**Meeting of the Planning Commission for the Town of Frisco
Town Hall, 1 East Main Street
Thursday, February 15, 2018 at 5:00 P.M.**

**PLANNING COMMISSION
STAFF REPORT**

AGENDA ITEM: Planning File No. 297-17-DA: A Development Application review of the proposed Vistas on Granite Street multi-family residential project

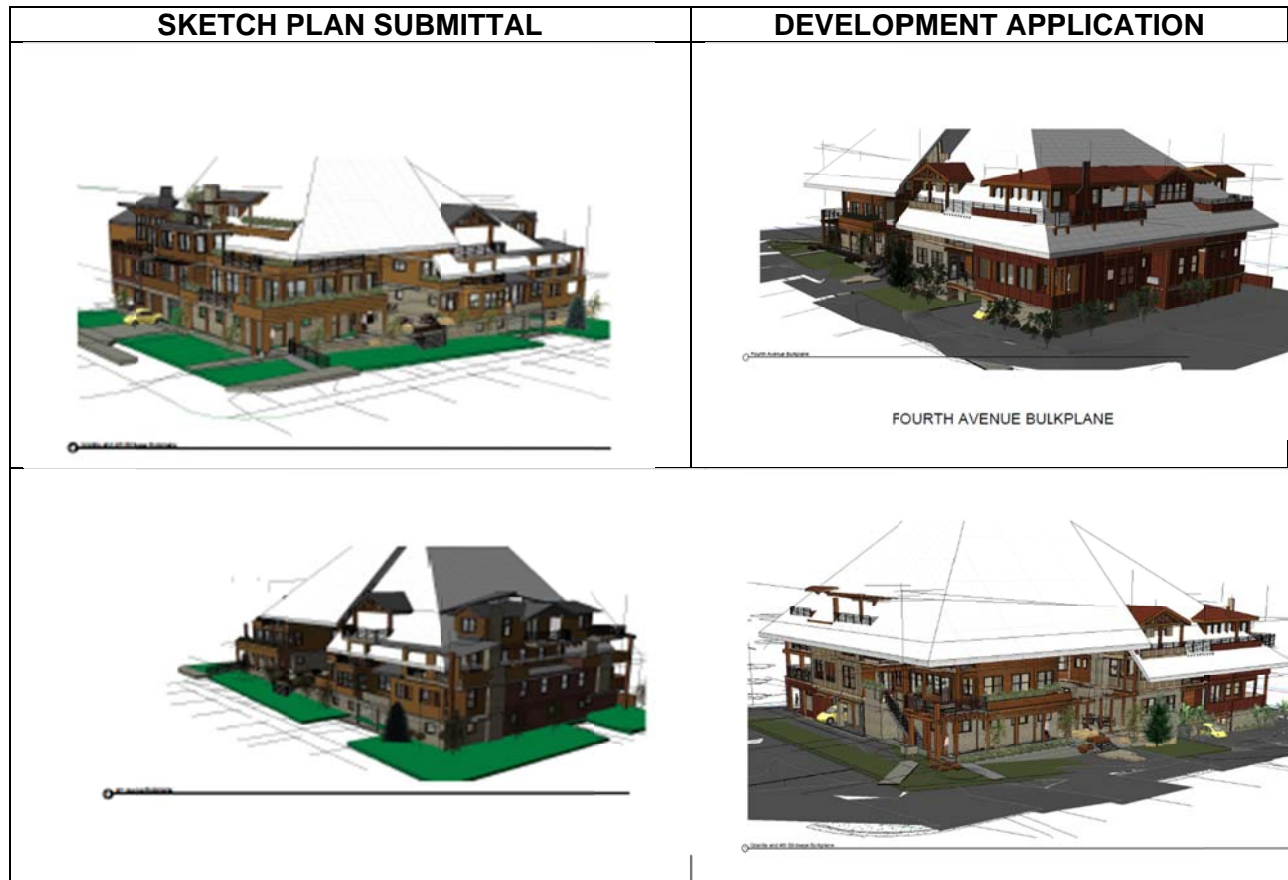
Elements of the proposed Vistas on Granite Street building deviate from the bulk plane envelope standards prescribed in Standard #2.4 of the Granite Street and Galena Street Overlay District. Building forms may project beyond the bulk plane if the Planning Commission finds that the forms comply with the building height limits and "provide substantial architectural

relief". At the August 3, 2017 Planning Commission meeting, the Planning Commission provided general feedback that they had concerns with the proposed bulk plane encroachments. As can be seen in the comparison below, the applicant has reduced the bulk plane along the South 4th Avenue and increased the bulk plane along Granite Street.

Staff believes that there is too much building mass outside of the bulk plane limits beyond what the criteria allows and the reasoning for when an encroachment may be allowed by the Commission – that being “architectural relief” that enhances the design. Our observation is that the encroachments actually detract from the overall design by creating more of a looming facade over the streetscape. Staff does not think that the bulk plane encroachments provide substantial architectural relief and recommend that the encroachments be further minimized. Should the Planning Commission find that the encroachments provide substantial architectural relief and advance the intent of Goal #2, then the application meets this standard.
